Service Bulletin

Repair procedure to additional wires protection

SB-ASTM-CTSW-16**SB-ASTM-CTLS-17****SB-CTLS-ELA-001****SB-ASTM-MC_-04****SB-LTUL-CTSW-15****SB-LTUL-CTLS-15**

An electrical short circuit occurred due to damage of the wire insulation that lead to contact of the wire to the steel part connected to electrical ground.

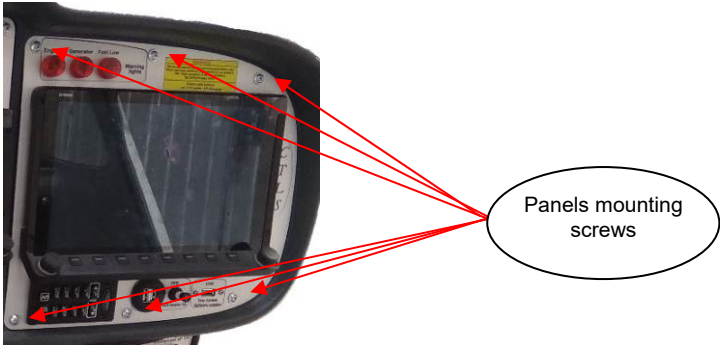
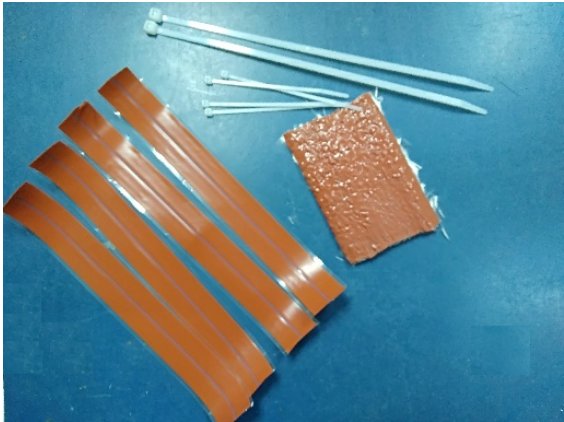
Step	Action	Reference
1	<p>Remove Panel Right section. Unscrew panel mounting screws.</p> 	
2	<p>Open additional wires protection set.</p> 	
3	<p>Pull out the wires as much as possible.</p>

4

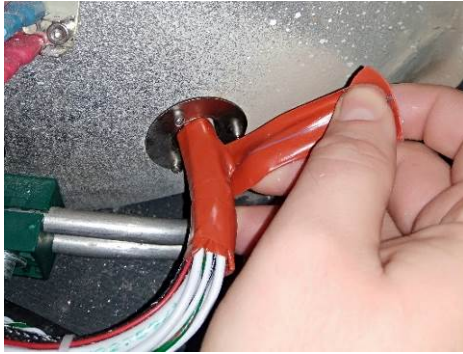
Remove the protective film from pyrosil tape. Wind the pyrosil tape around the wires*.

*Installation: Stretch tape during installation using at least a 50% overlap. For best results, use on clean, dry surfaces free from dirt and oil.

The protective layer must be at least 5 layers.

5

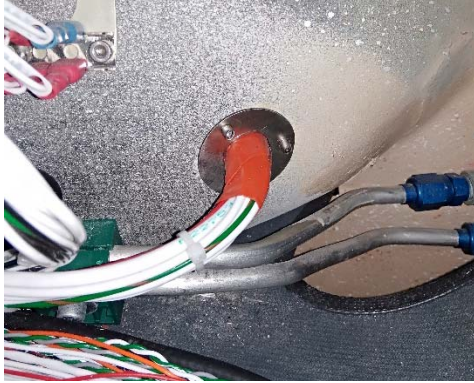
Return the wires to their original position.

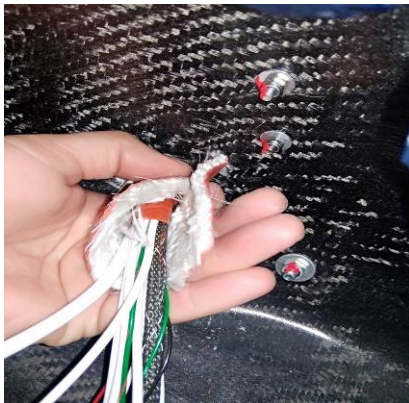
Wrap fire protection hose around flange and wires. Tighten TY-wraps around flange and wires.
